Request for Information

M-R RFI Log No.: **03 (Pre-Bid)**

VA Project No.: **528-13-C-0179**

Project Name: **Renovate 6B Ward Syracuse VAMC**

Date	10-15-2014
Project No.	528A7-13-745
DRAWING NO.	MH-101
Dwg. 31	Of 81

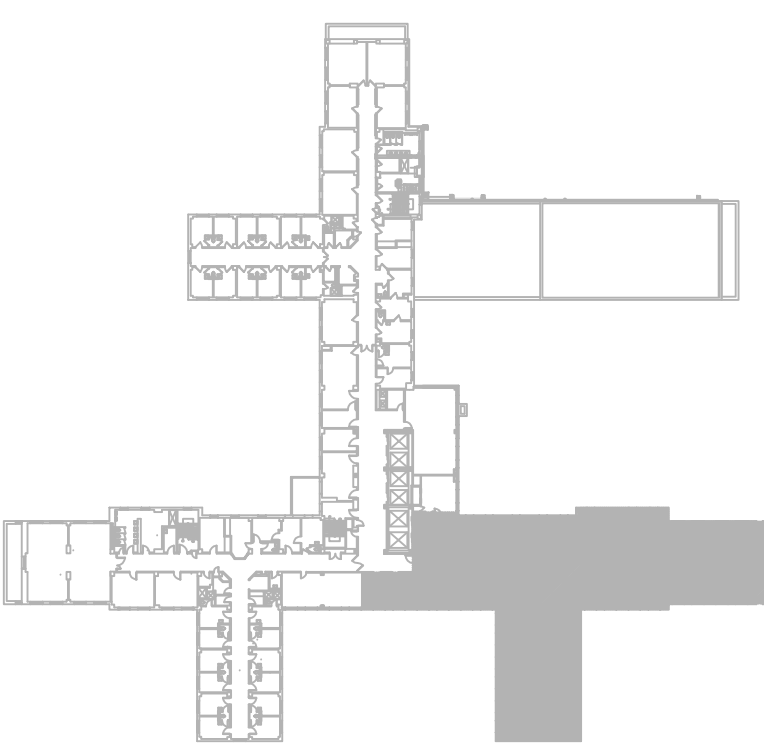
1. TU-09 and TU-17 are on drawings but not on schedule?
2. TU-6 is listed twice on schedule, is there one or two?
3. TU-6, TU-7, TU-8, TU-10, TU-12, TU-14 and TU-15 are on schedule but not on drawing. Do they exist?

1. Drawing MH-101 was revised to change TU-6 to TU-9. Drawing MP-103 was revised to change TU-17 to TU-15. See attached revised drawings with the changes clouded.
2. Drawing M-602 was revised to change TU-6 in Soiled Utility to TU-9. See attached revised drawings with the change clouded.
3. These terminal units are shown on the ductwork plans (MH drawings) but not on the piping plans (MP drawings) since there are no heating coils associated with these boxes.
4. The changes to the drawings have to do with a partition type change. The changes are clouded and shown on Drawings GI-100, AS-102, & AS-400.
5. The use of a double or 8 module alarm panel would provide expansion space of two modules (one per wing) which is acceptable subject to owner approval.
